**Vermont Department of Environmental Conservation**

July 3, 2019

Re: Vernon Hydroelectric Project (FERC No. 1904)  
Comments on Low Impact Hydropower Certification

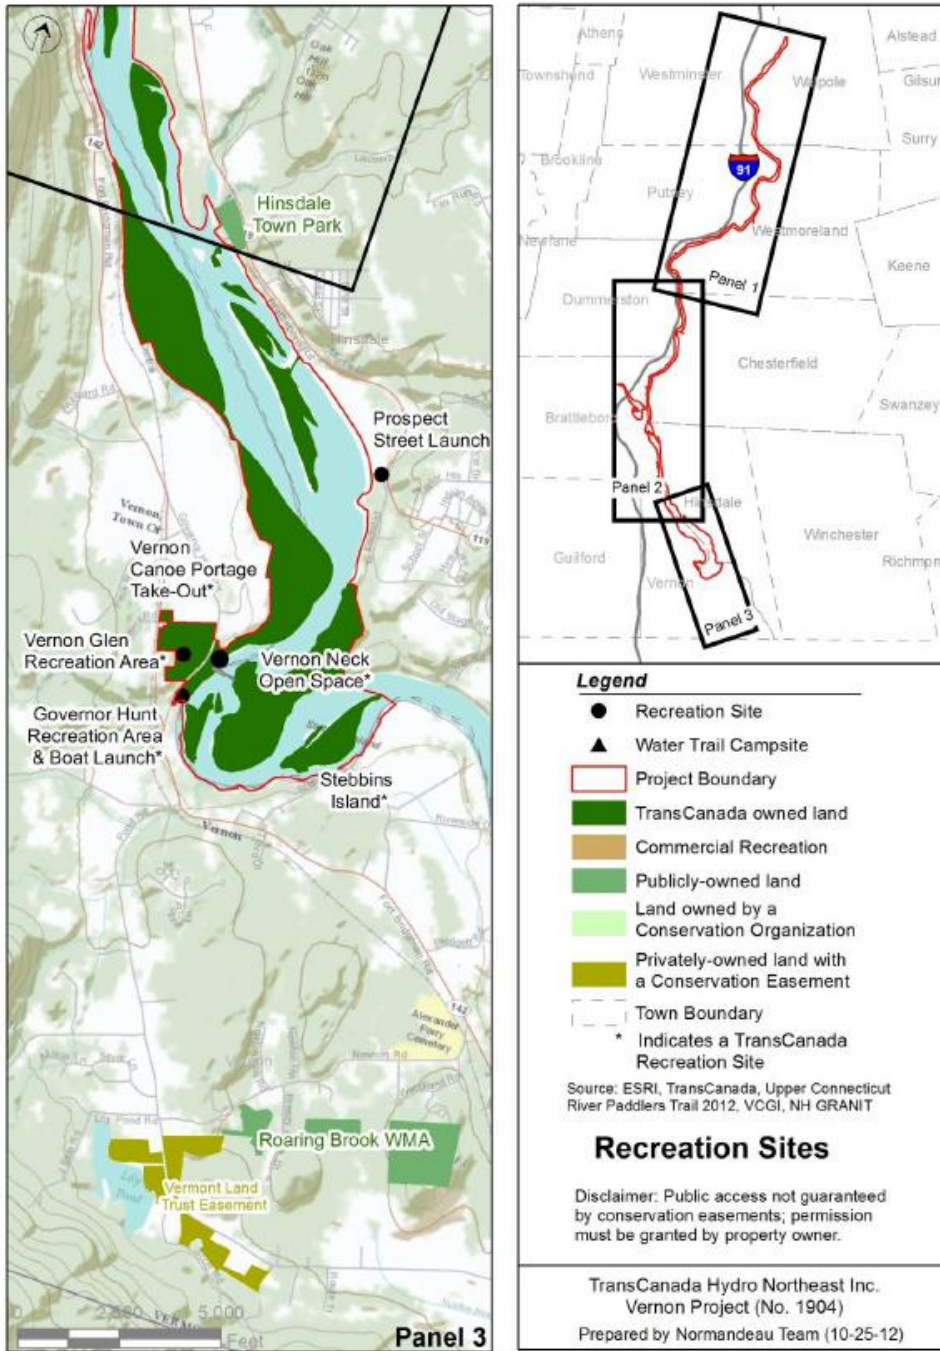
GRH states that a portion of their owned land lies within Zone 2, “but is largely necessary for project related uses”. However, while most of the land is largely necessary, it is not wholly necessary for project related uses. Therefore, Vernon does have an impact – albeit a small one compared to the overall impoundment size and owned land, but not negligible compared to other LIHI certified facilities. Please see Figure 1 for an image of GRH owned land near the Vernon Project. This figure was presented in the FERC relicensing process in the pre application document. The map also notes locations where recreation takes place on GRH lands.
